Company	Trenz Electronic GmbH
PCN Number	PCN-20210611
Title	TE0729-02 eMMC Change
Subject	BOM change
Issue Date	2021-08-05

2.1 #1 Change eMMC (U5) from IS21ES08G-JCLI to SDINBDG4-8G-XI2

Locate eMMC (U5) on bottom side of PCB:

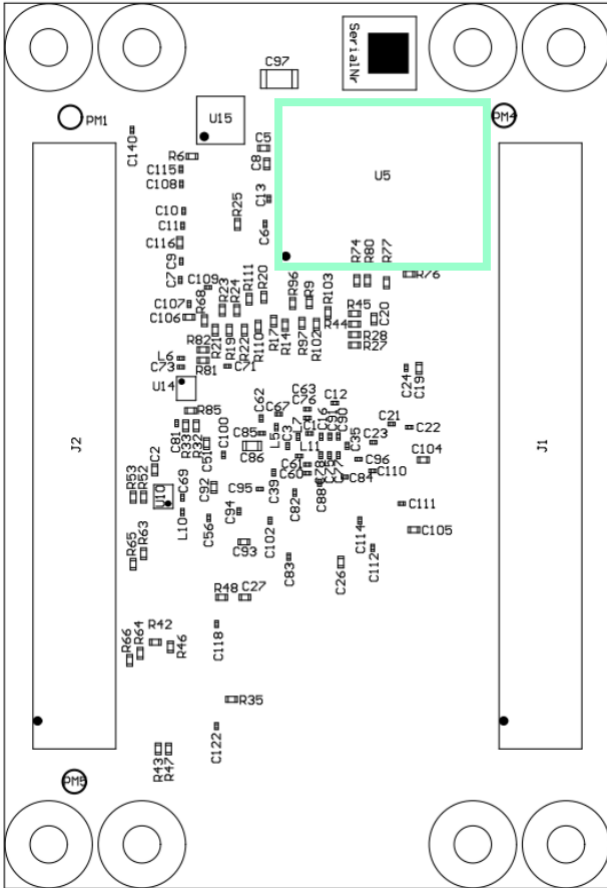
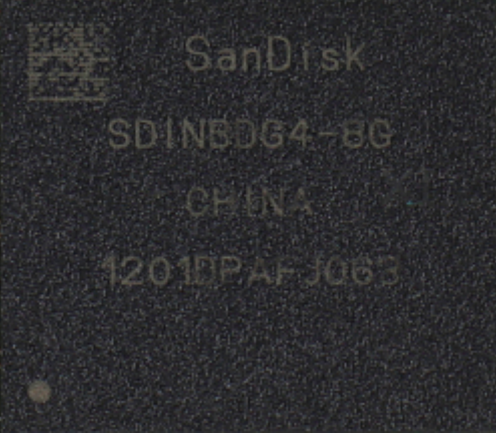
Reason: Distributor informed about unforeseeable immediate EOL of parts. No official documents from manufacturer are available. No LTB, already confirmed orders were canceled by distributor/manufacturer.

Impact: None. Replacement has same capacity as used on corresponding affected variant. Reference designs for vivado versions 2019.2 and 2020.2 were tested and work properly without any changes.

old	new
IS21ES08G-JCLI	SDINBDG4-8G-XI2
